Service Bulletin

CBR1000RR-R #1

SAFETY RECALL

2021 CBR1000RR-R (SP) - REAR CUSHION CONNECTING PLATES

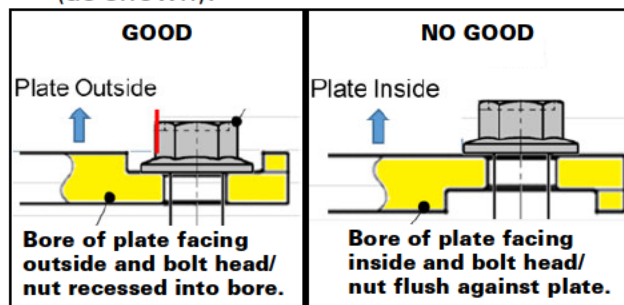
1. Visually check that the bores of the left and right rear cushion connecting plates are facing outside.

The cushion connecting plate bolt head and nut should both be recessed into the bores of their plates if installed correctly (as shown).

- If the motorcycle has the plates installed correctly, no repair is needed. Immediately file warranty template claim KL9A for INSPECTION ONLY.
- If the motorcycle does not have a plate installed correctly, a repair is needed. Contact TechLine for repair determination and parts information. **DO NOT** file a warranty claim at this time.
